HDC-2022-00035

Address: 811 W. Gordon Street

District: Old Allentown Historic District

Proposal: Reconstruct side and rear walls of rear ell

Existing condition of rear ell facing Refwal Street. (Applicant)

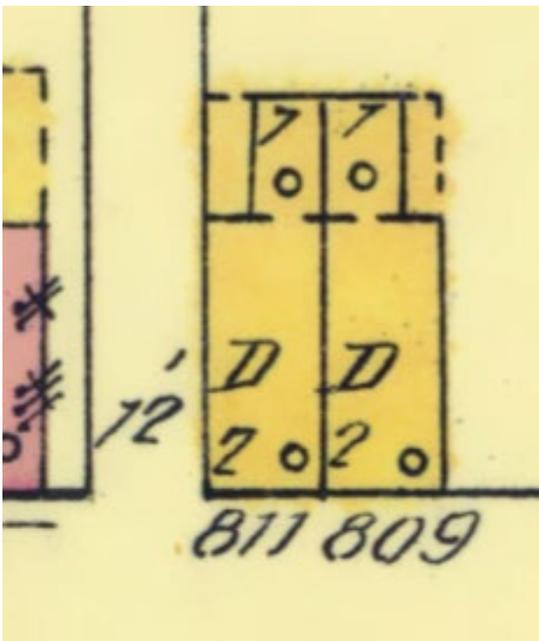
This application proposes to demolish and reconstruct the one-story rear ell. The applicant contends that the existing condition of the rear ell is beyond repair and requires reconstruction. The photograph provided by the applicant showing the existing conditions appears to illustrate that the ell has already been partially reconstructed with a new slab foundation, rafters, and plywood covering the walls. The floor plan indicates that one door will be installed in the rear wall with no other openings proposed. One boarded opening is shown in the photograph on the Refwal Street elevation. The staff questions whether the two other openings on the Refwal Street façade will be reconstructed.

The staff has requested additional information to determine whether the reconstruction of the ell is appropriate. Specifically, staff has requested elevation drawings or annotated photos with all exterior dimensions to show the proposed appearance of the ell; details and measurements of each building feature; a list of materials/features to be salvaged and reinstalled; and details on proposed windows, doors, and any new materials. Staff requested photos to illustrate the conditions and the necessity for reconstruction. The photos submitted appear to show a new condition rather than the deteriorated condition of the ell.

With sufficient evidence, the staff may find that reconstruction is appropriate. If more documentation is provided and it is found that reconstruction is necessary, the staff recommends that the reconstructed ell replicates the building's original appearance and complies with the previously approved work related to the door relocation and installation of new siding matching the original wood in dimension and style. The staff recommends that the applicant follows the original approvals (as detailed above) in replicating the historic windows, doors, and siding and that the dimensions, profiles, materials, locations, and proportions of all historic features are maintained.
